Subject: Response to Request for Additional Information – WCAP-15872-NP, Rev. 0, “Use of Alternate Decay Heat Removal in Mode 6 Refueling.”

**WCAP-15872, "Use of Alternate Decay Heat  
Removal in Mode 6 Refueling"**

**WCAP-15872-NP, R00**  
**"Use of Alternate Decay Heat Removal in Mode 6 Refueling"**  
**Request for Additional Information**  
**dated October 2, 2003**

Figure A-3  
Sample Cases: Average Refueling Pool Temperature

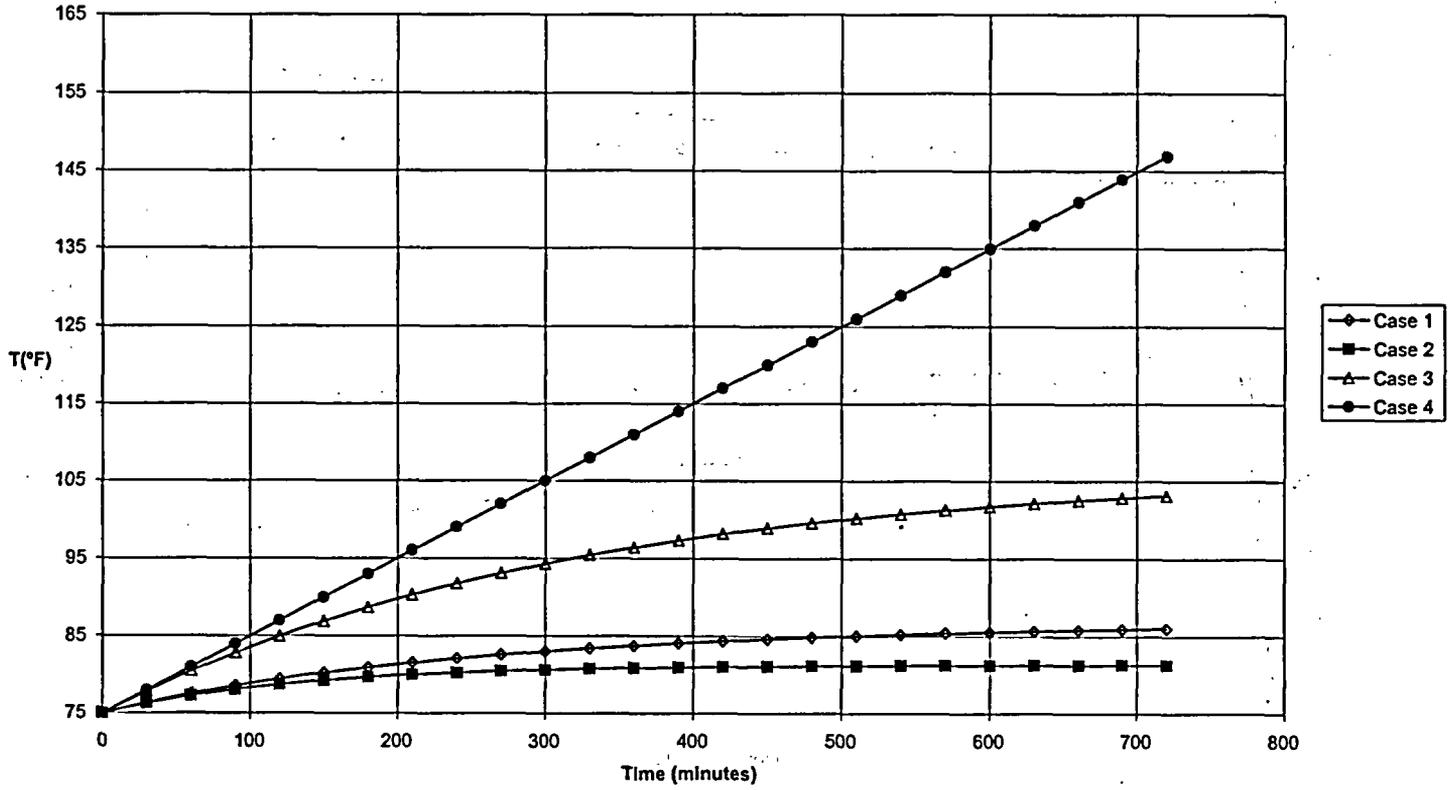
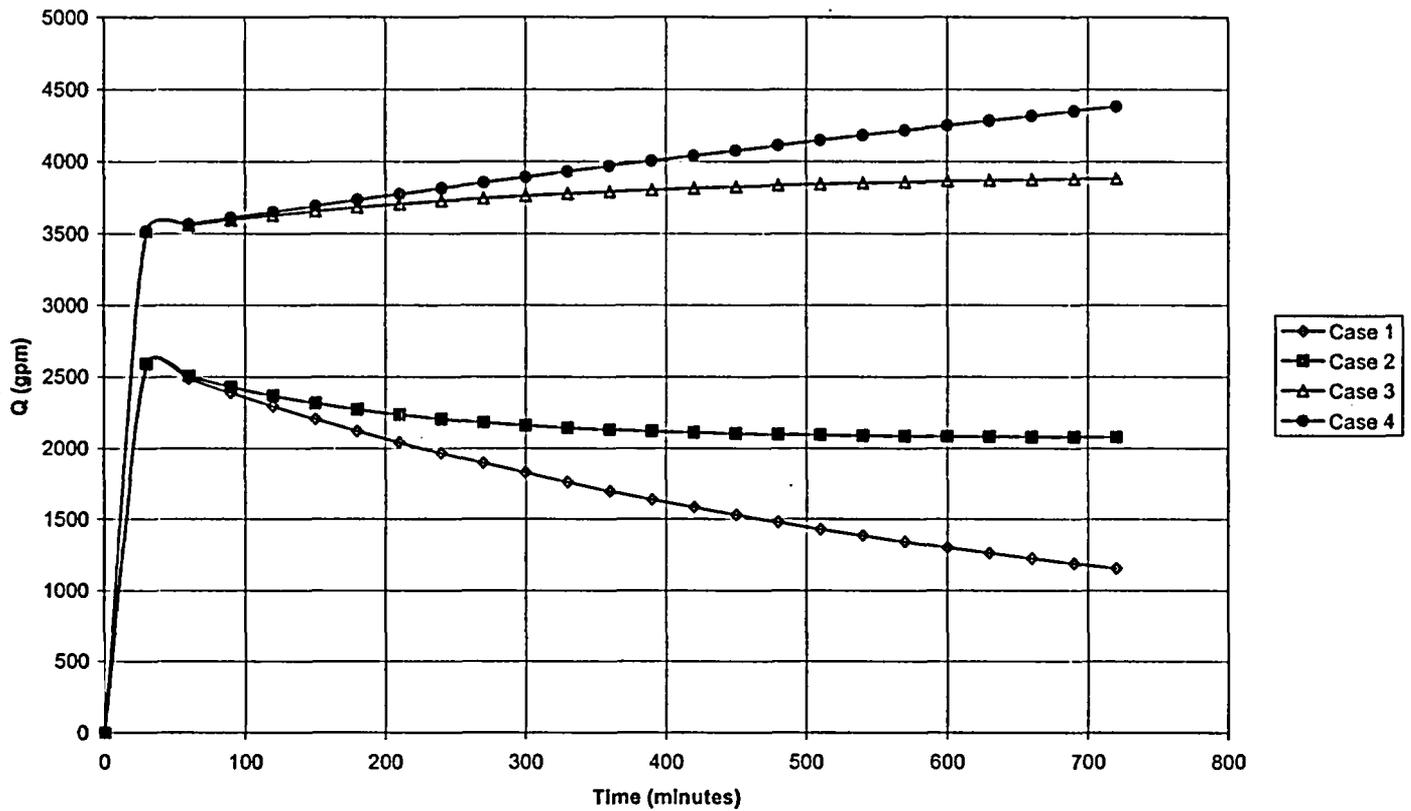
*RAI A7. Please show the derivation of the values of  $\epsilon_{mix}$  and  $\epsilon_{bypass}$  used in the results shown in Figs. A-3 and A-4 for Case 2 and Case 3.*

The mixing and bypass coefficients are defined in Appendix A and derived as shown in Appendix D. However, for the results shown in Figure A-3 and Figure A-4, these coefficients were assumed well mixed, i.e.,  $\epsilon_{mix} = 1.0$  and all alternate heat removal flow fully mixed with the natural convection flow from the core,  $\epsilon_{bypass} = 0.0$ . In Appendix A, Case 2 represents full SDC flow plus alternate cooling flow; Case 3 represents only alternate cooling flow. (Note that sample Cases 1 – 4 in Appendix A are not the same as test Cases 1 – 4 listed in Appendices B, C and D.)

**Figure B-4**  
**CCNPP Unit 2 Outage Tests: Spent Fuel Pool Flow Rate and Temperature versus Time**

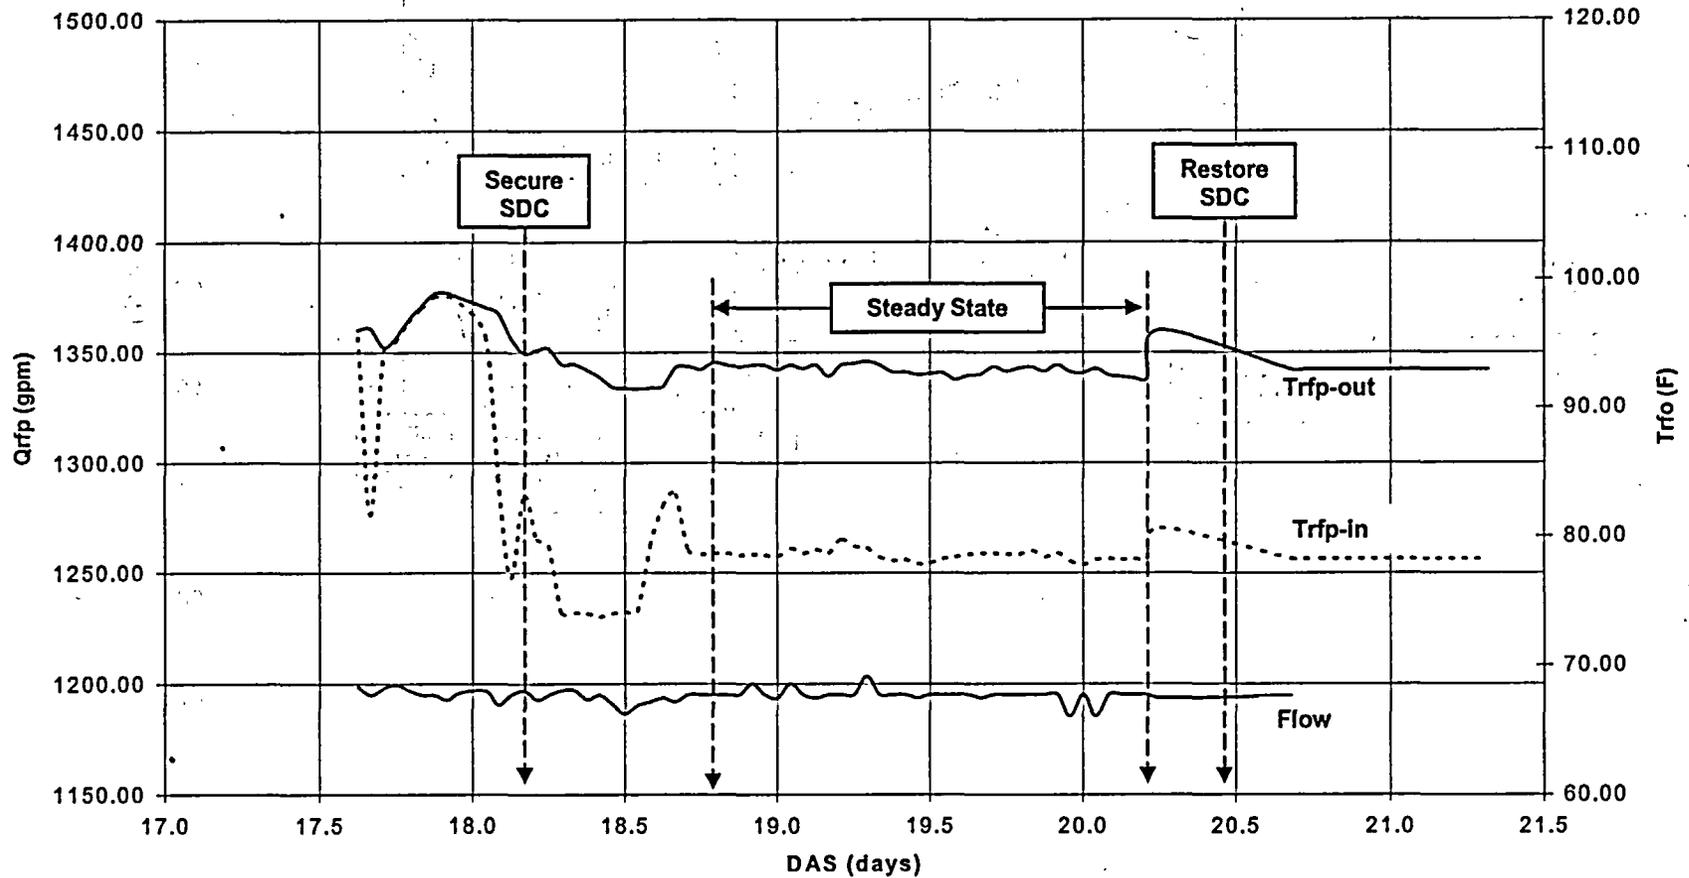
*RAI B4. Table B-2, B-3 and B-4 report time in days, hours and minutes respectively. Also, the figures use two different time scales. Please resubmit for review all tables and figures based on one time scale. (If there is a specific reason, such as clarifying a relationship, state so.)*

Time scales in Tables B-2, B-3 and B-4 are expressed in terms of clock time, total elapsed time and time in days after shutdown in order to expediently illustrate a particular result. For example, an event having a duration of minutes is not easily illustrated if expressed using a time-scale of days. Total elapsed time is used to compare measured and predicted values, while days after shutdown is the important parameter for tracking the point at which changes such as initiation and securing of shutdown cooling, head removal, initiation and securing of alternate cooling, and return to shutdown cooling occur.

**Figure D-2**  
**Flow Paths for Bypass Flow**

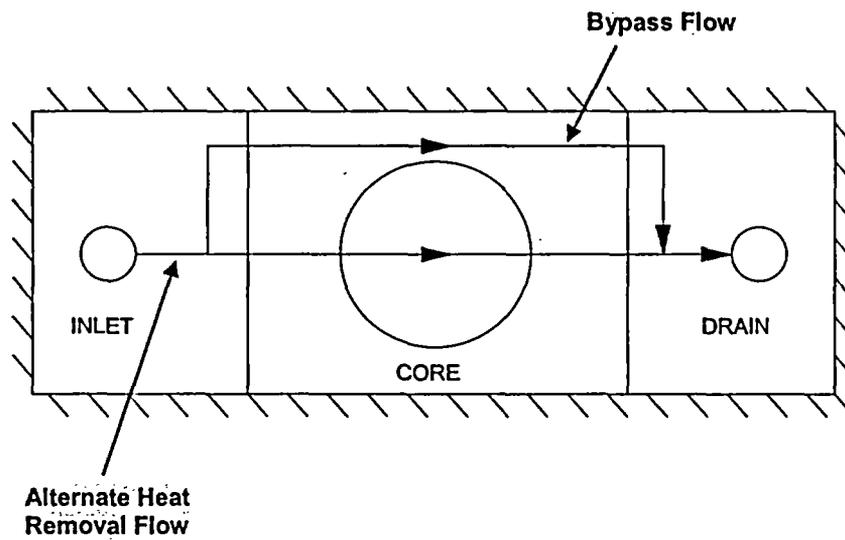
*RAI D1. Please describe the simplified one-dimensional computational model and its relation to the two-dimensional computational fluid dynamics model. How does it differ from the one-dimensional model discussed in Appendix A? When you say "computational fluid dynamics model" (without the adjective "one-dimensional") in D.3, what are you referring to - A 3D model? Figures D-3 through D-6 give 2D results. So, how are you treating the situation in Figure D-2?*

The mixing and bypass coefficients reflect three-dimensional effects into the one-dimensional analysis, shown in Appendix A, for natural circulation flow rates and refueling pool temperatures. The mixing coefficient is a measure of the uniformity of the refueling pool temperature, while the bypass coefficient, represented schematically in Figure D-2, is an indicator of the flow rate from the alternate cooling alignment that bypasses the natural circulation plume from the core.
